<b>Project:</b>	LG Dam Safety Improvements	<b>RFT No.:</b>	2021-RFT-012
<b>Addendum No.:</b>	1	<b>No. of Pages:</b>	2
<b>Doc. No.</b>	P7201-313612880-35(1.0)	<b>Date:</b>	June 28, 2021

PROJECT NAME:  
LAKE GERALDINE DAM  
2021 REHABILITATION PROGRAM

DRAWING TITLE:  
CONCRETE DAM PLAN & ELEVATION

SHEET No.  
**C2.0**

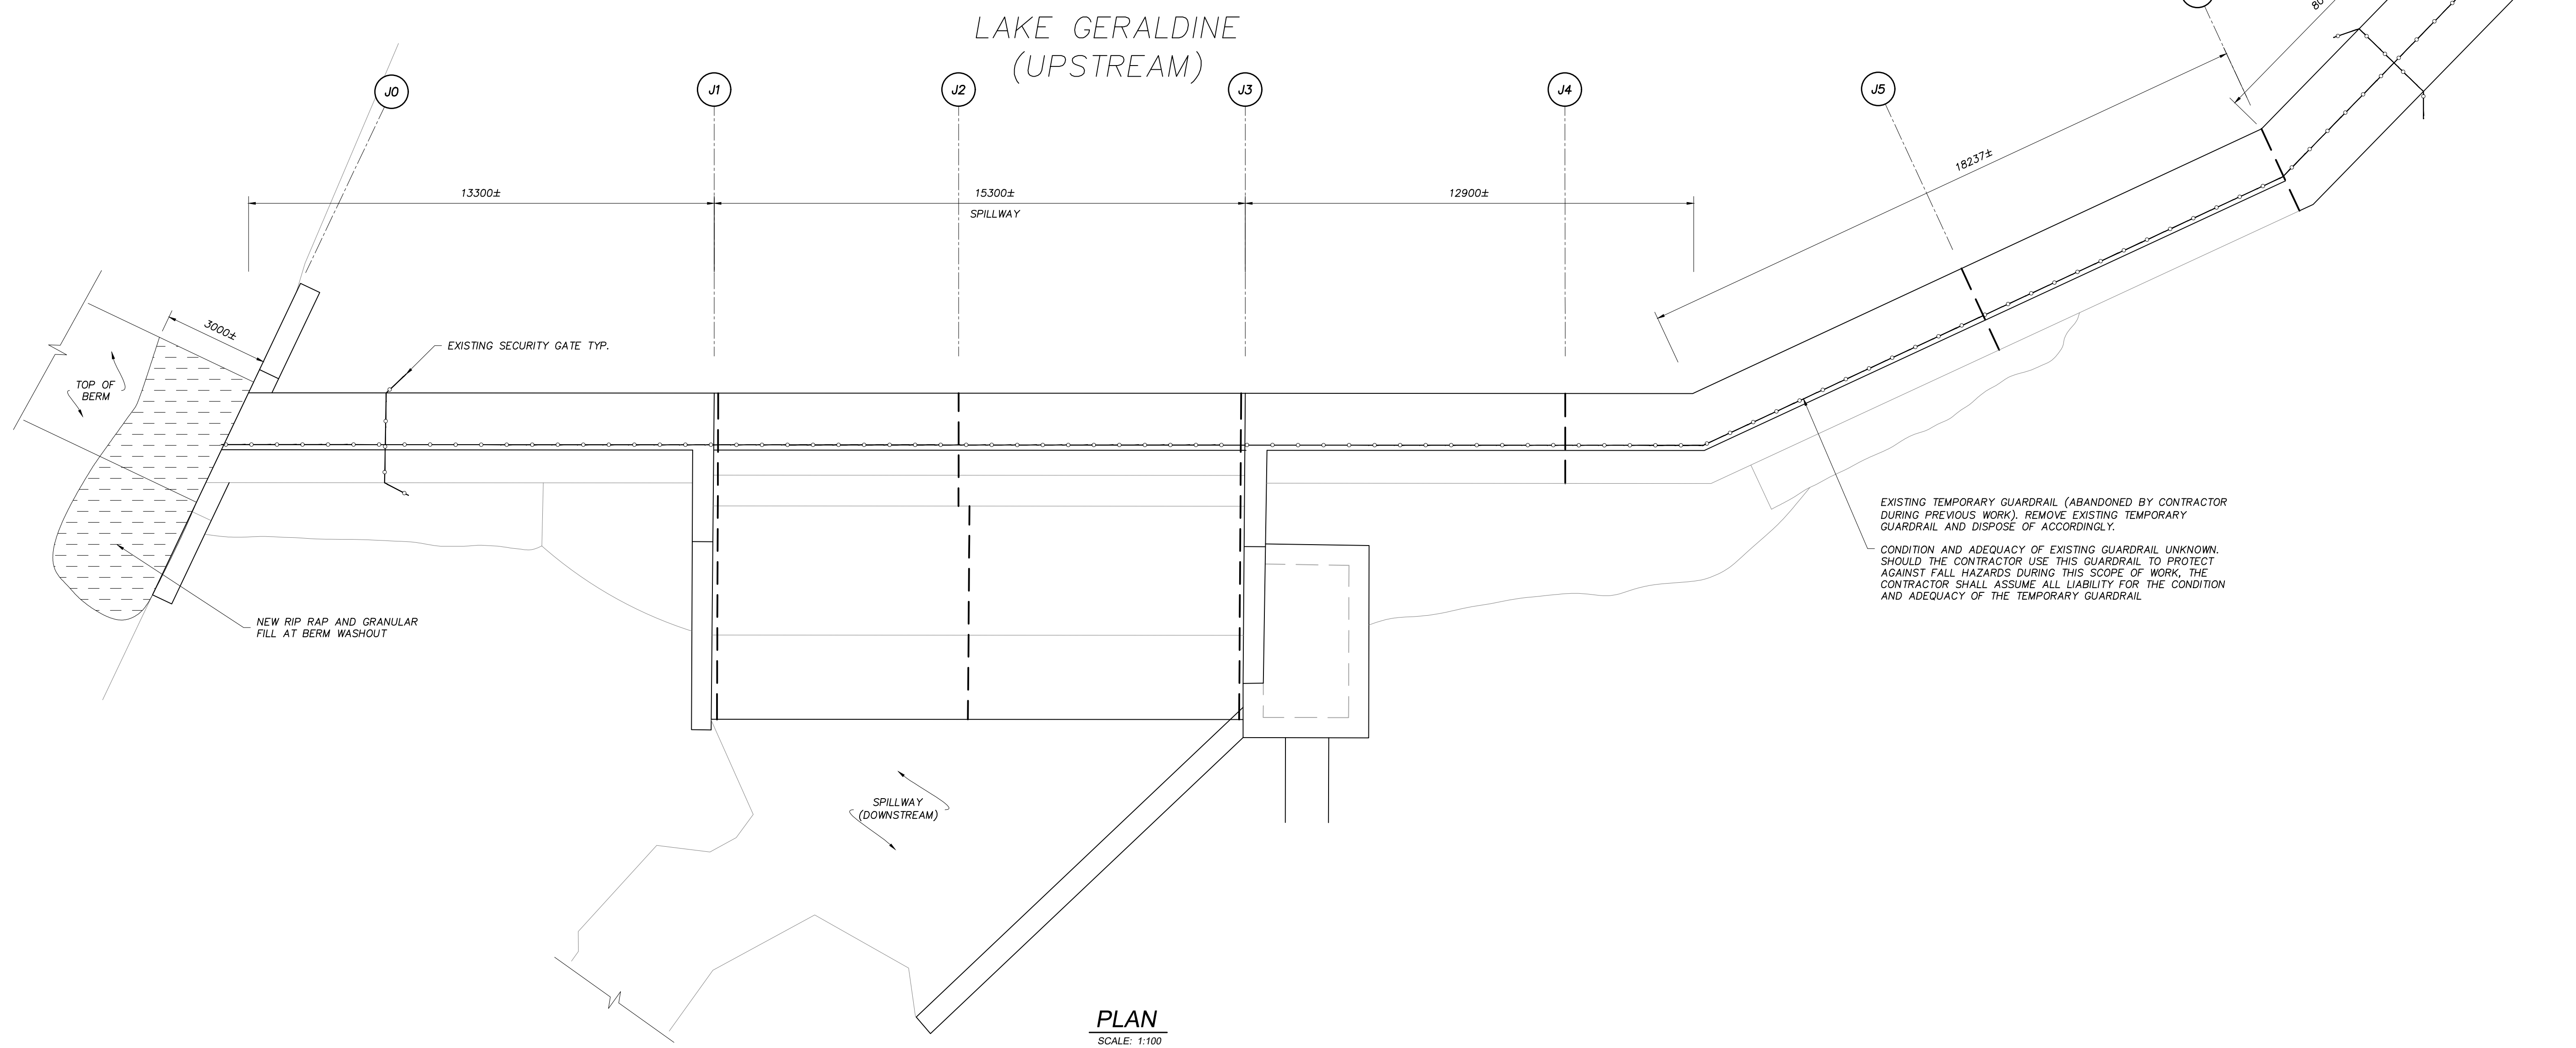
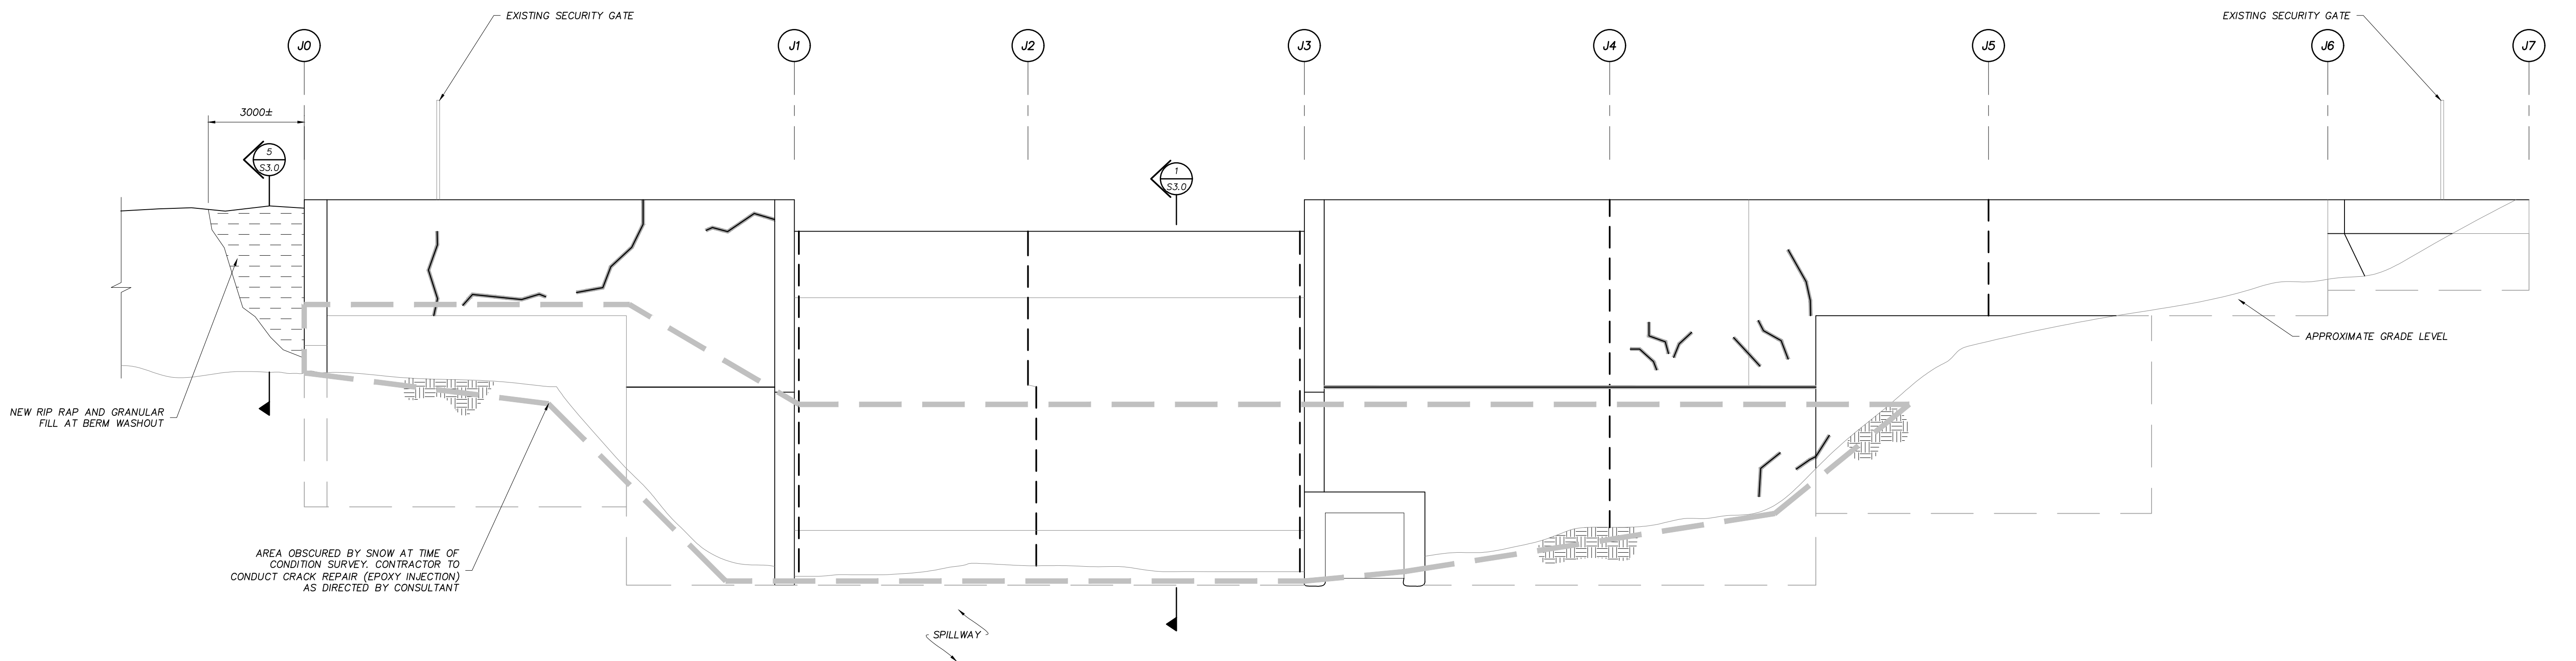
1.3	<p>Bidder Question</p> <p>Question: On drawing C2.0 the dashed lines for the temporary guardrail as well as the dashed lines for the expansion joints are very similar. Could you clarify which lines are for the expansion joints?</p> <p>Answer: See attached drawing C2.0 Issued for Addendum No.1 dated June 28, 2021.</p>

1.4	<p><b>Clarification:</b> As noted on drawing C2.0, the guardrail was not previously abandoned by a contractor but rather requested to be left in place by the City for safety purposes. This material belongs to Kudlik Construction Ltd. and must be returned to Kudlik in its entirety if removed.</p>
